CATEGORY: Recommended at next maintenance

Summary: CarnaudMetalbox Engineering Ltd introduces a catch assembly for the slideway guard on the 5000 Bodymaker. The catch assembly locks the slideway guard lid in position when opened, thus preventing inadvertent closure of the slideway guard lid and acts as a safety device should the gas struts malfunction. The catch assembly can be retrofitted by attaching the assembly to the slideway guard lid and skirt.

Figure 1

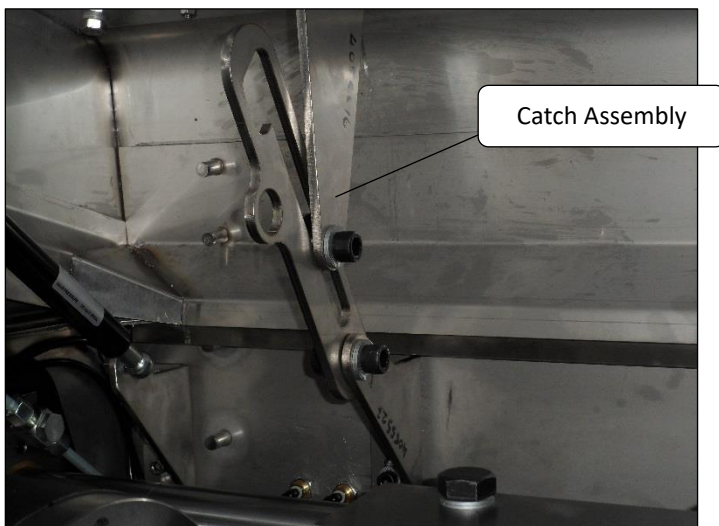
This improvement ensures that operator safety is maintained and eliminates the risk of potential injury.
